ADDENDUM NO. 1

DNR-250004 GREAT COUNCIL OBSERVATION TOWER

1587 US-68,
Xenia, OH 45385

T-G2

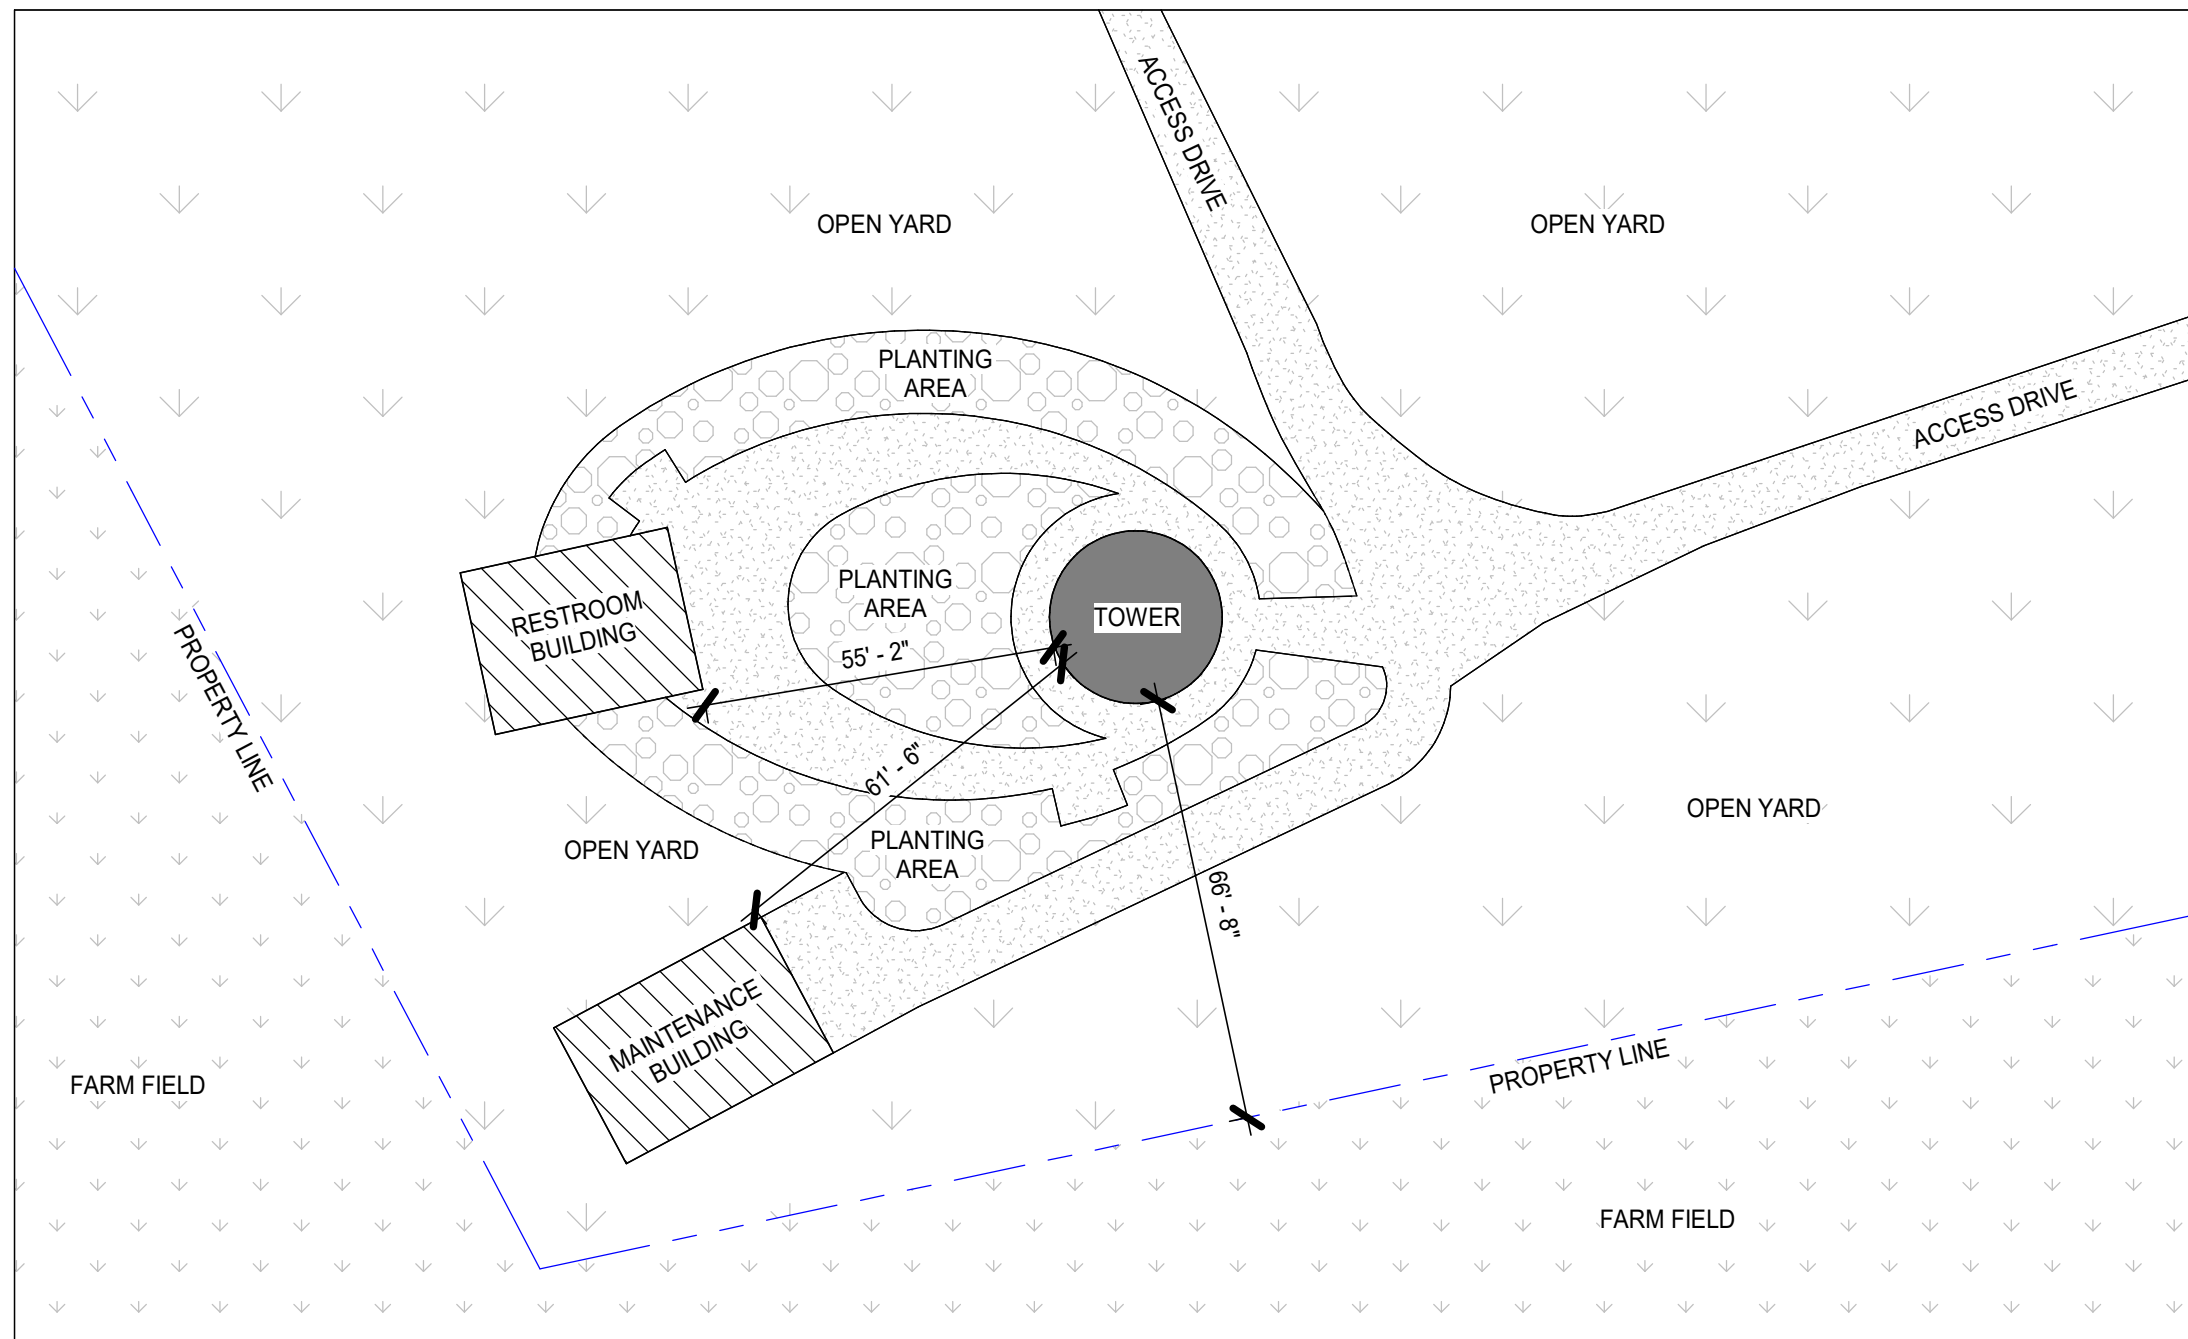
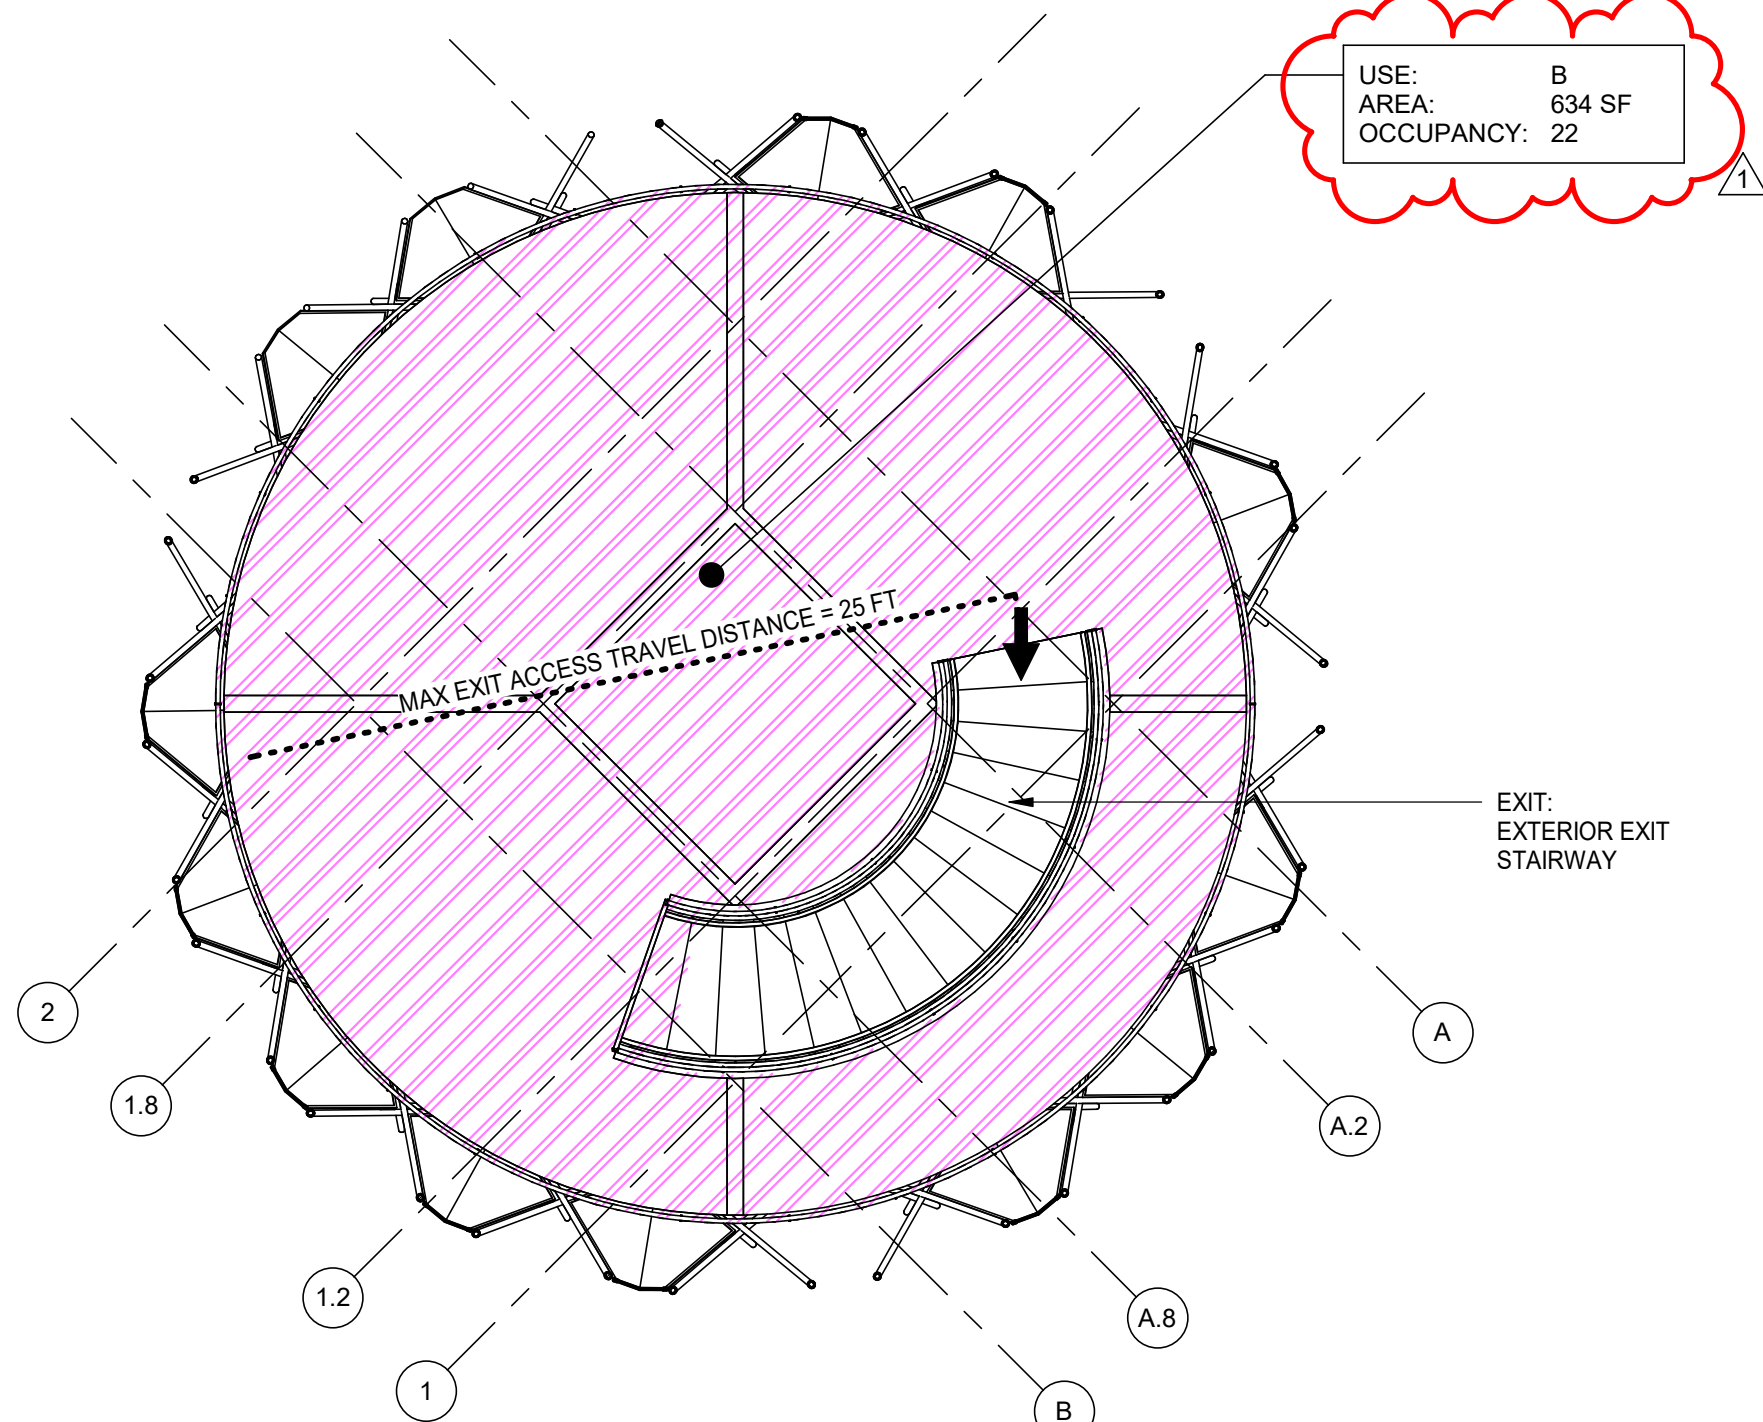
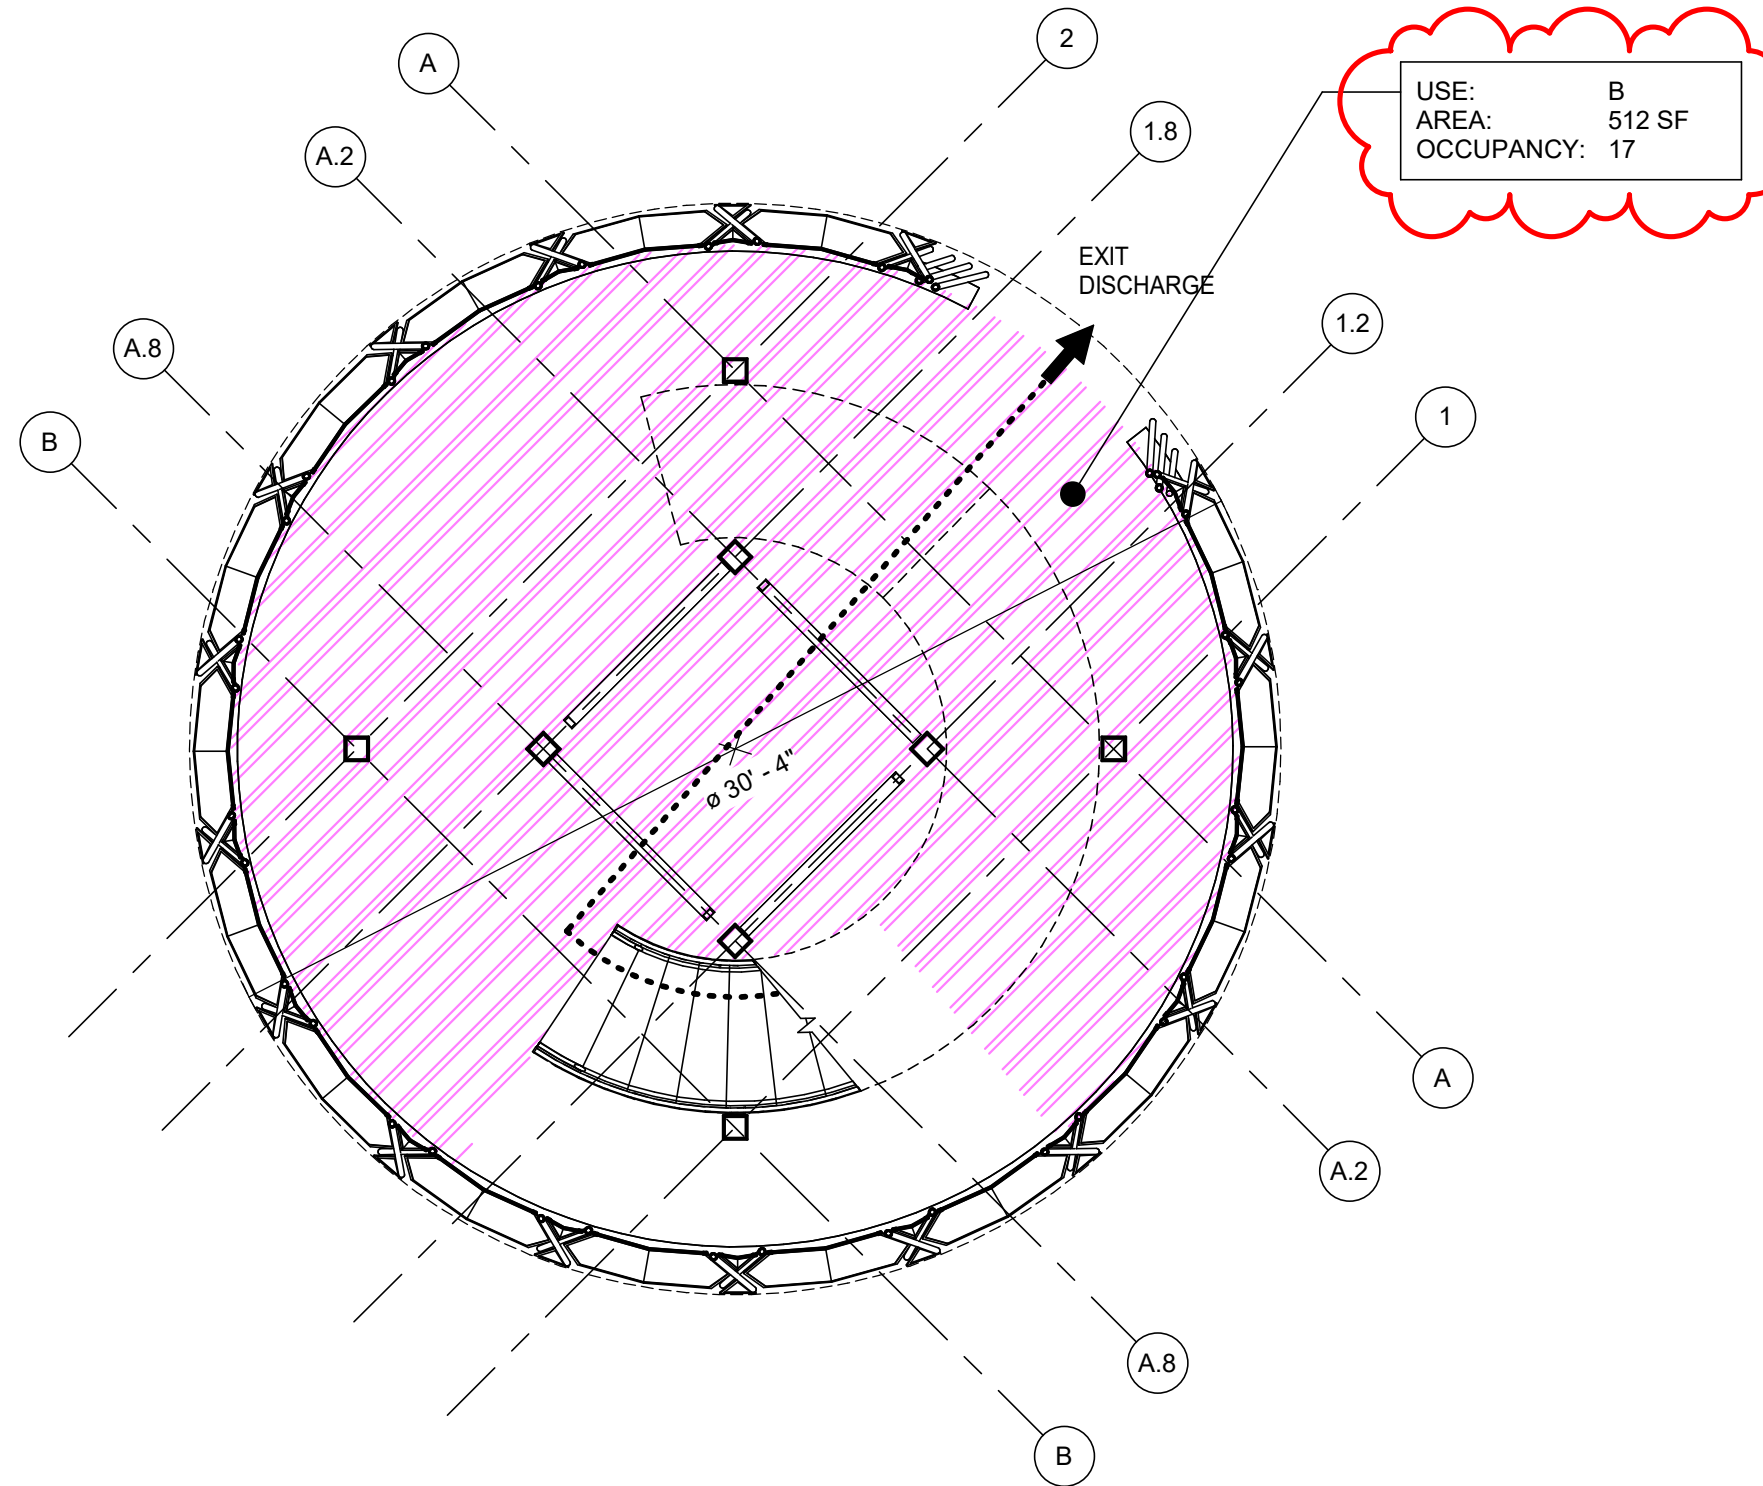
ITEM 5 T-G2 – CODE ANALYSIS - TOWER

Revised occupancy to B use.
